UNITED STATES PATENT AND TRADEMARK OFFICE

APPLICATION NO.	FILING DATE	FIRST NAMED INVENTOR	ATTORNEY DOCKET NO.	CONFIRMATION NO.
09/918,886	07/30/2001	Ting K. Yee	20852-05682	3294
35690	7590	02/27/2006	EXAMINER	
MEYERTONS, HOOD, KIVLIN, KOWERT & GOETZEL, P.C.			KIM, DAVID S	
P.O. BOX 398			ART UNIT	
AUSTIN, TX 78767-0398			PAPER NUMBER	
			2633	
DATE MAILED: 02/27/2006

Office Action Summary	Application No. 09/918,886	Applicant(s) YEE ET AL	
	Examiner David S. Kim	Art Unit 2633

DETAILED ACTION

FIG. 14A

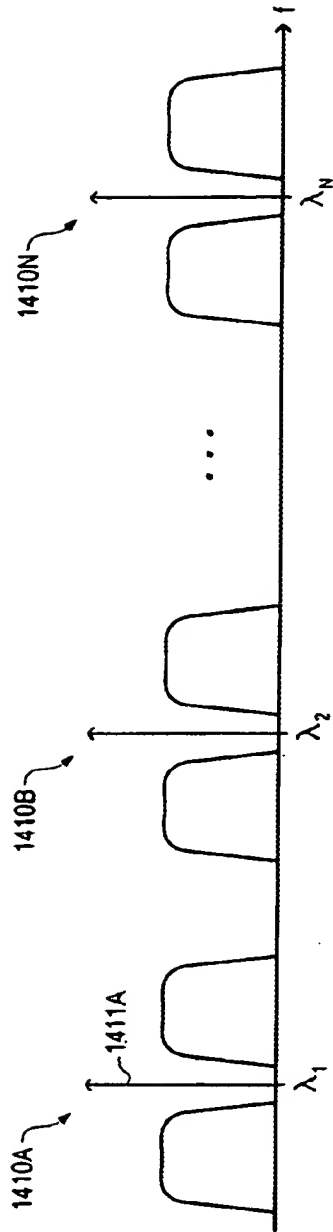
In Fig. 14A, label the lower sideband to the left of optical carrier 1411A with "1412A(L)" and label the upper sideband to the right of optical carrier 1411A with "1412(U)" as shown in old Fig. 14A filed on 30 July 2001. See paragraph [0086] for support.

FIG. 16

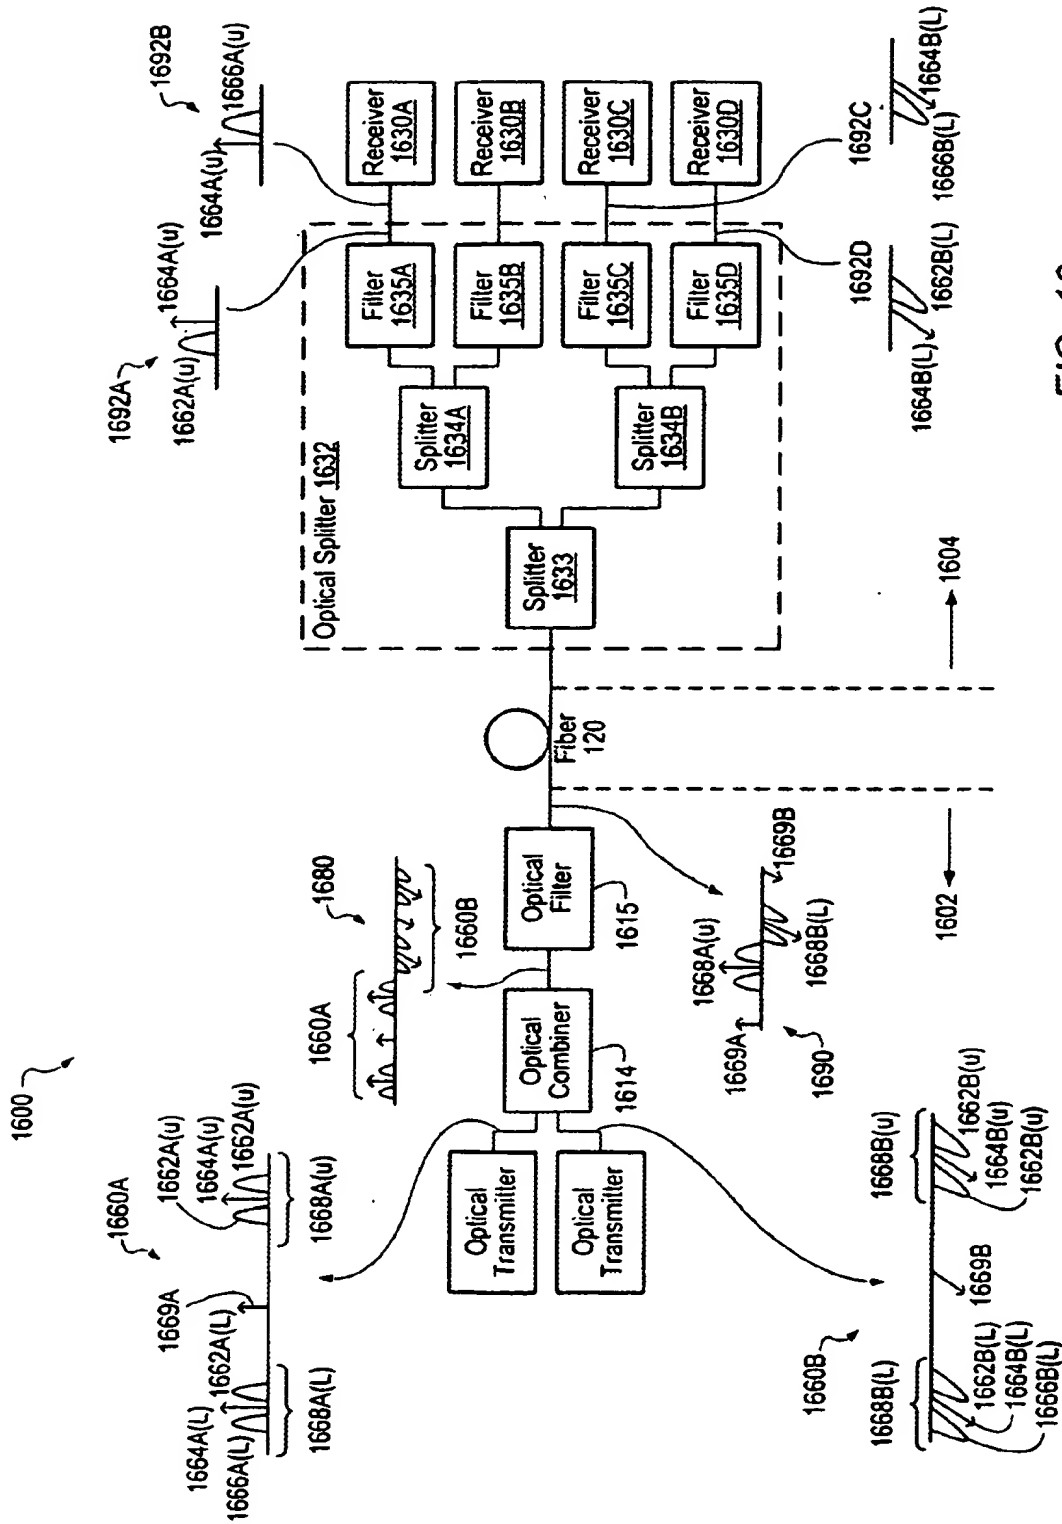
In Fig. 16, label the upper optical transmitter with "1610A" as in old Fig. 16 filed on 30 July 2001. Also, label the lower optical transmitter with "1610B" as in old Fig. 16 filed on 30 July 2001. Otherwise, the reference character "1610" in paragraphs [0043, 0047, 0050, 0054] is not in the figures. Also, see paragraph [0108] for support.

In Fig. 16, replace the rightmost "1662A(u)" with "1666A(u)" as shown in old Fig. 16 filed on 30 July 2001. See paragraph [0109] for support.

In Fig. 16, replace the rightmost "1662B(u)" with "1666B(u)" as shown in old Fig. 16 filed on 30 July 2001. See paragraph [0110] for support.

In Fig. 16, extend the lead line for spectrum 1692B to the input line for receiver 1630B. Otherwise, Fig. 16 shows spectrum 1692A and 1692B for the input line to receiver 1630A.

FIG. 17

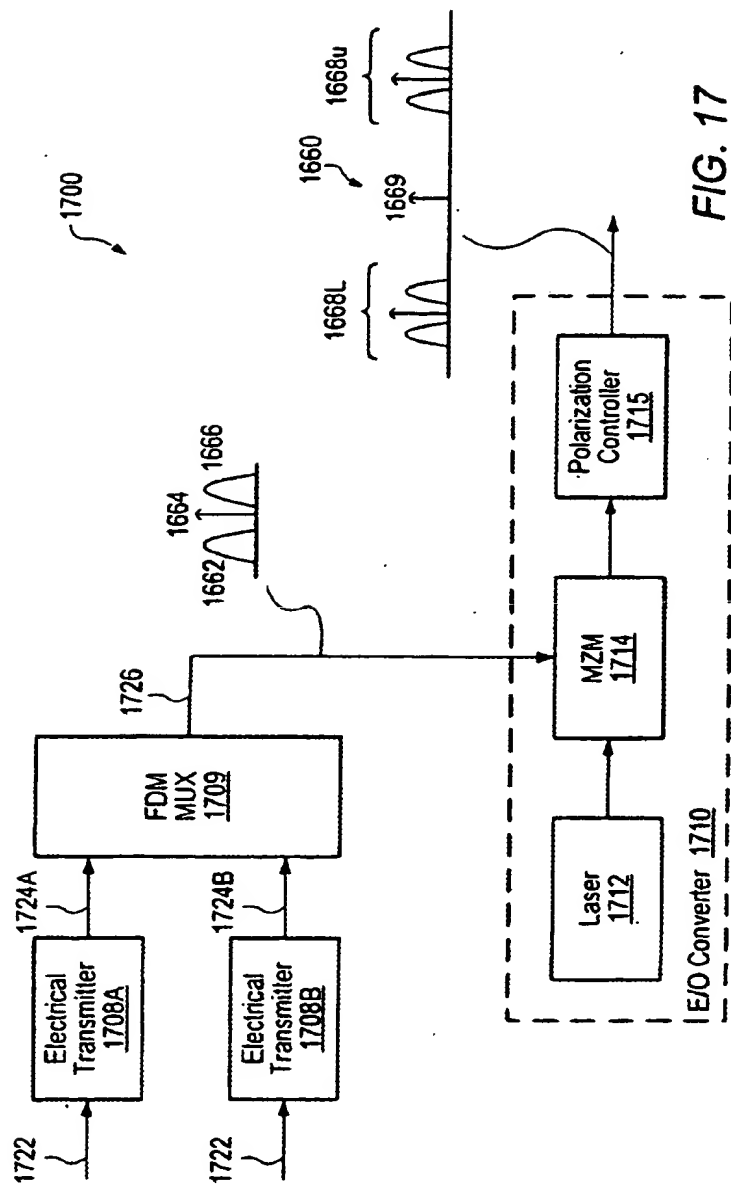
In Fig. 17, remove reference character "1700" and its lead line since it does not appear in the specification.

FIG. 18A

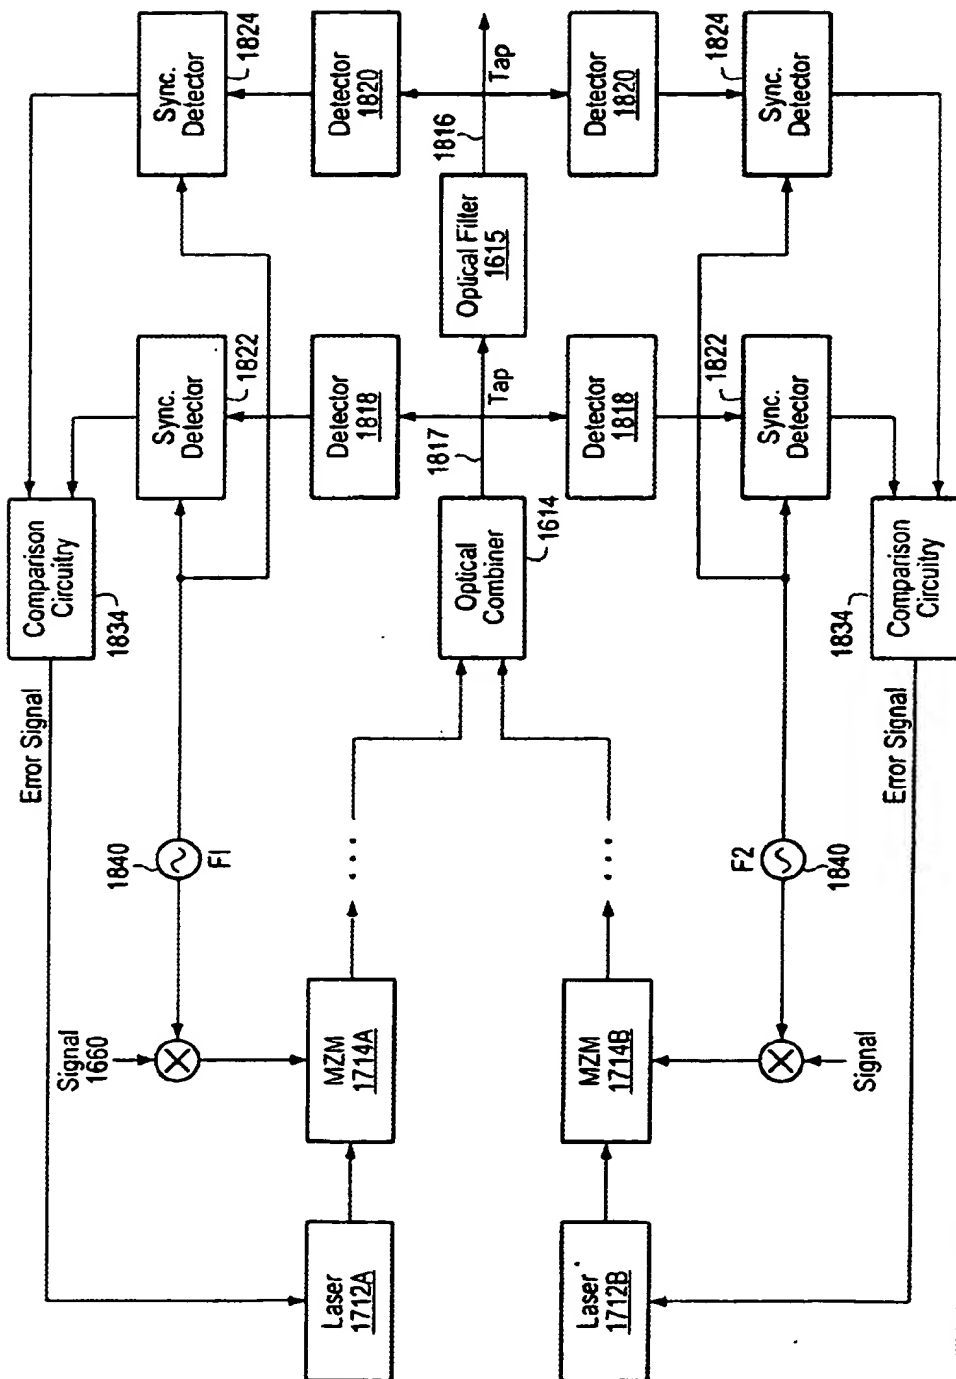
Applicant responded to the drawing objection regarding **claim 13** by amending Fig. 18A to show all of the features recited in claim 13. However, amended Fig. 18A is disapproved. In Fig. 18A, much of the bottom half is not supported by the specification and constitutes new matter. For example, the original disclosure does not disclose the bottom detectors 1818 and 1820, the bottom sync detectors 1822 and 1824, the bottom comparison circuitry 1834, and the associated connections. Rather, Fig. E-23B in provisional application 60/265,251 supports just one detector 1818, one detector 1820, one sync detector 1822, one sync detector 1824, one comparison circuitry 1834, and the associated connections. Accordingly, the drawing objection to claim 13 remains. The drawings remain objected to under 37 CFR 1.83(a). The drawings must show every feature of the invention specified in claim 13. No new matter should be entered. As a remedy, Examiner respectfully suggests amending Fig. 18A to correspond more closely to supported Fig. E-23B in provisional application 60/265,251.

In Fig. 18A, add a reference character "1800" that points to the entire device. See paragraphs [0044-0045, 0126] for support.

In Fig. 18A, much of the bottom half is not supported by the specification and constitutes new matter. For example, the original disclosure does not disclose the bottom detectors 1818 and 1820, the bottom sync detectors 1822 and 1824, the bottom comparison circuitry 1834, and the associated connections. Rather, Fig. E-23B in provisional application 60/265,251 supports just one detector 1818, one detector 1820, one sync detector 1822, one sync detector 1824, one comparison circuitry 1834, and the associated connections. Amend Fig. 18A to correspond more closely to supported Fig. E-23B in provisional application 60/265,251.

FIG. 18B

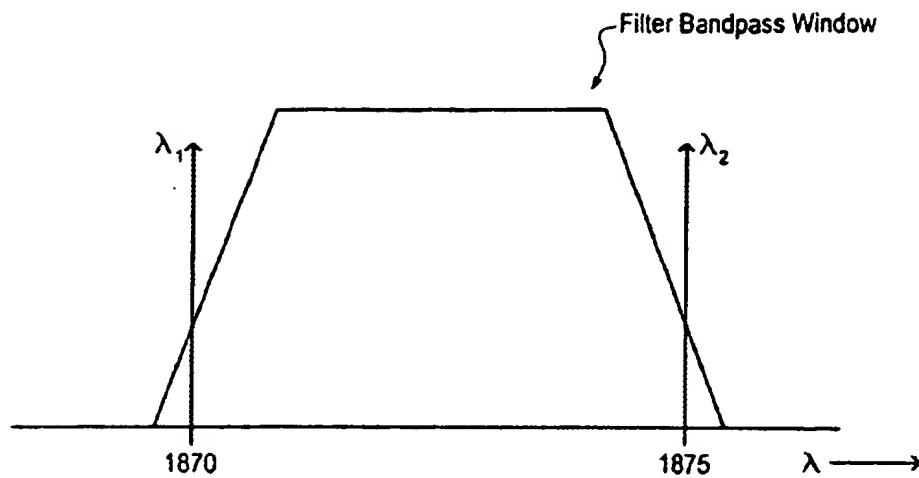
-- The same approach is used to wavelength-lock the optical carrier 1669B generated by optical source 1712B. In Fig. 18B, the nominal wavelength 1875 of carrier 1669B is also located at 6 dB of attenuation, but at the upper edge of the filter transfer function. Thus, too much attenuation means the wavelength is too high, and too little attenuation means the wavelength is too low. --

Otherwise, reference character "1875" is missing from the specification.

FIG. 22

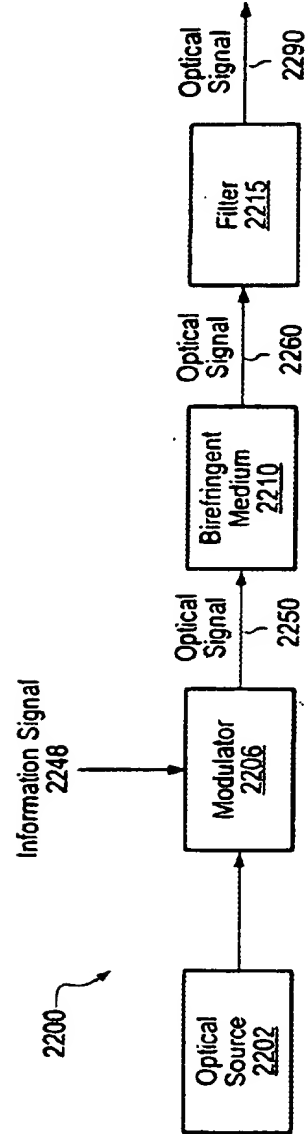
Applicant responded to the drawing objection regarding **claim 5** by pointing to Fig. 22 as support for the claim language in claim 5. However, Fig. 22 is directed to non-elected Species II (designated in an Office Action mailed on 03 November 2004). Accordingly, the drawing objection to claim 5 remains. The

drawings remain objected to under 37 CFR 1.83(a). The drawings must show every feature of the invention specified in claim 5. No new matter should be entered. As a remedy, Examiner respectfully suggests the submission of a new figure showing the limitations of claim 5 or the cancellation of claim 5.
